ADDENDUM No. 2

LITTLE PAPIO CREEK LEVEE/CHANNEL CULVERTS CONSTRUCTION PROJECT (GROUP A CULVERTS)
DOUGLAS COUNTY, NEBRASKA
BID LETTING DATE: 24 February 2022

19 February 2022

CONCRETE TRAIL DETAIL 2
NOT TO SCALE
D.3

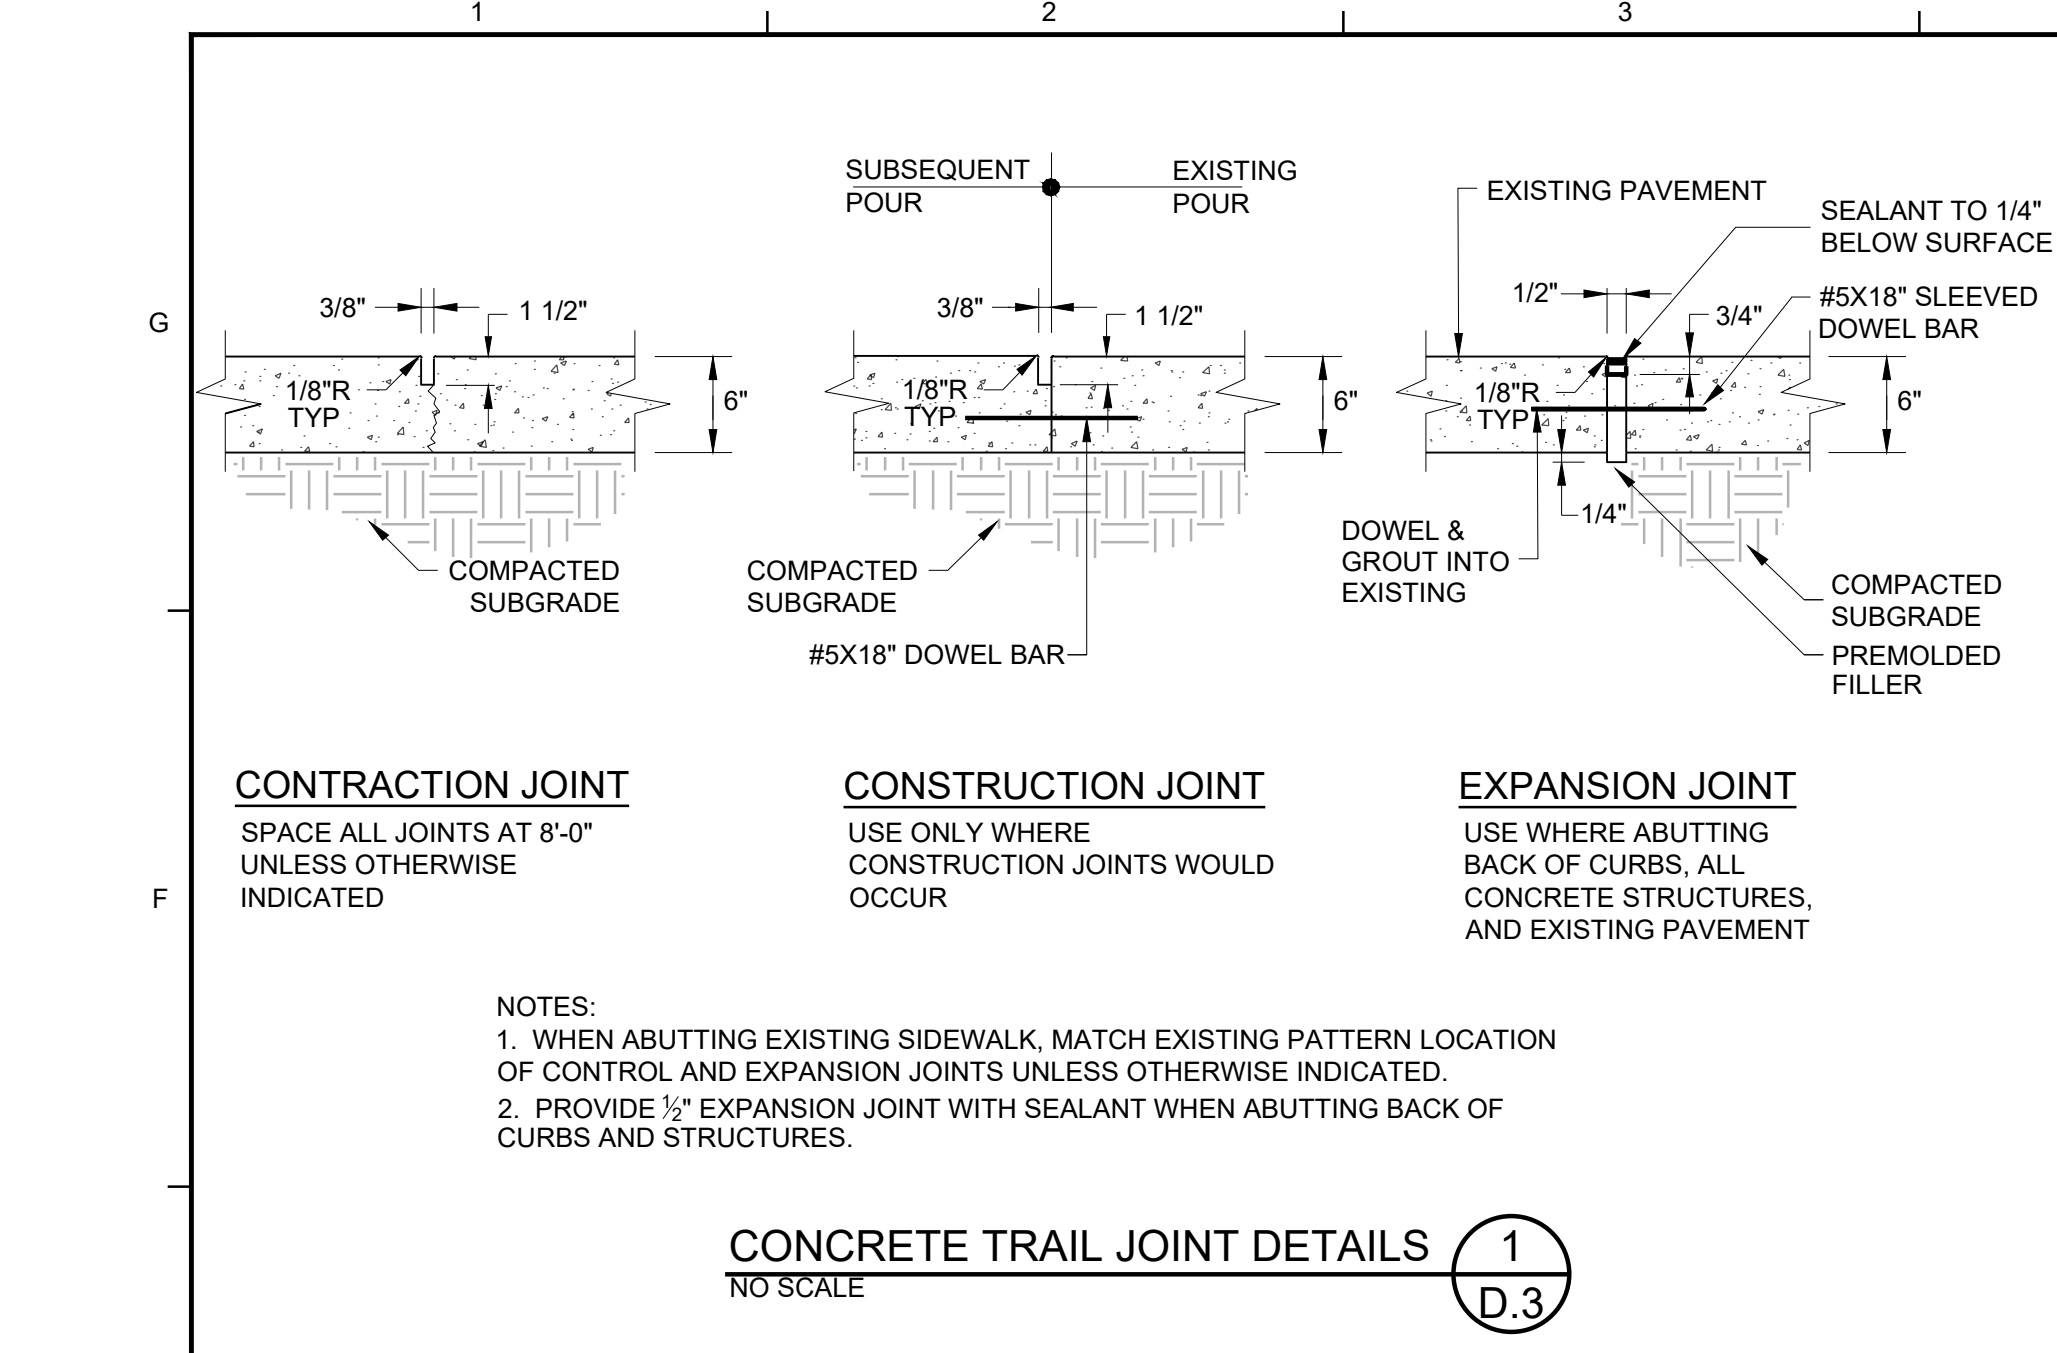
- A. General Notes (Sheet A.2) – An updated General Notes (Sheet A.2) document is included with this addendum. Updates to noted section include addition of **General Note #42 “TREE REMOVAL CANNOT OCCUR BETWEEN JUNE 1ST AND JULY 31ST and General Note #43 “PRESSURE TESTING OF REHABILITATED JOINTS IN EXISTING RCP CULVERTS WILL NOT BE REQUIRED AFTER REHABILITATION IS COMPLETED.”**
- B. Quantities (Sheet A.3-B) – An updated Quantities (Sheet A.3-B) document is included with this addendum. Updates to noted section include change of bid item **2.087** from **48” DIA MANHOLE** to **54” DIA MANHOLE** to correspond to the information shown on the plan and profile sheet for culvert LP-L26.
- C. Details (Sheet D.3) – Detail 2-D.3 callout for trail material type shall be modified to state “PROPOSED 6” THICK **L65 1PF CONCRETE**” and not L65M. An updated Sheet D.3 is attached.
